SUMMARIZATION OF NEW APPENDICES (B, C, D, E, F, G, H, I)

REVISION: C (supersedes Rev B, dated June 2, 2026)

TO: The City of Lebanon Wastewater Treatment Plant Site Selection Committee & Lebanon City Council

RE: Supplemental Public Comments and Risk Assessment regarding the Proposed 20 MGD Wastewater Treatment Facility

Exhibit C-1: 0.5-mile, 1.0-mile, and 2.0-mile rings centered on 3230 Mann Road, plotted on the TDEC Water Wells Desktop Application map. Each dark dot represents a permitted private water well in the TDEC database.

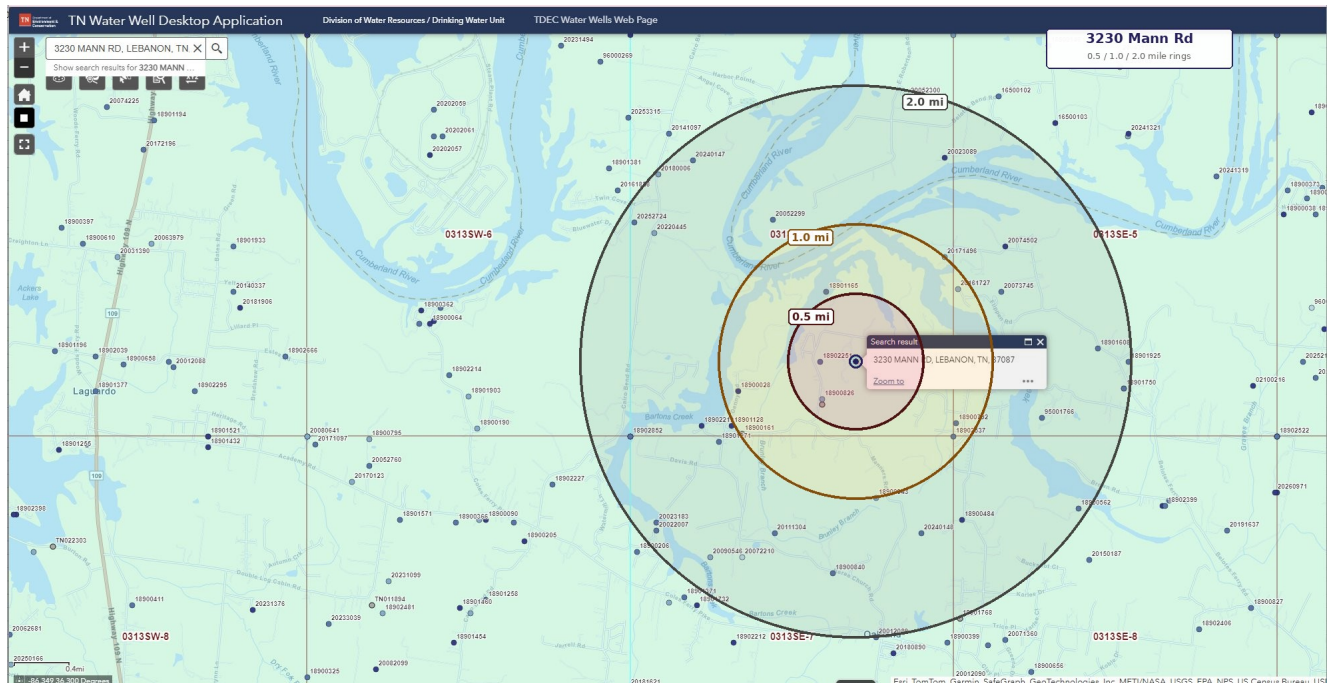
A query of the Tennessee Department of Environment and Conservation (TDEC) Water Well Locations public database identifies **a minimum of 38 permitted private wells within the 2-mile contamination radius** surrounding the proposed Mann Road and Berea Church Road footprint. Of these:

- **6 wells are located within 0.5 miles** of a proposed site, including a well at 1079 Berea Church Road (Coster) situated approximately 850 feet (0.16 mi) from the Mann Road site;
- **16 wells are located within 1.0 mile** of a proposed site;
- **38 wells are located within 2.0 miles** of a proposed site, the outer boundary of the karst contamination radius identified in Section VI.

The geographic distribution of these wells, with concentric 0.5-mile, 1.0-mile, and 2.0-mile rings, is depicted in Exhibit C-1 below. Recorded uses include residential drinking water (32 wells), agricultural and irrigation (9 wells), and geothermal heat pump (3 wells). The Site Selection Committee has not, to the petitioners' knowledge, entered these figures into the public record.

Important caveat: The figure of 38 wells is a minimum. The TDEC Water Well Locations database includes only those wells for which a licensed driller filed a report. Wells drilled prior to the

- Formally request a hydrogeological study from a qualified third party documenting (or refuting) hydraulic connectivity between the proposed site footprint and the LUD well field;
- Require coordination with the LaGuardo Utility District Board of Commissioners as a prerequisite to any further consideration of the Mann Road and Berea Church Road addresses;
- Enter the well-count data and accompanying ring map (Exhibit C-1) into the official public record of the site selection proceedings, and supplement it with an independent staff verification against the most current TDEC Water Well Locations database;
- Provide written notification to each identified well owner, and to all LUD ratepayers, of the proposed siting and the karst-aquifer contamination pathway described in Section VI of the principal statement.
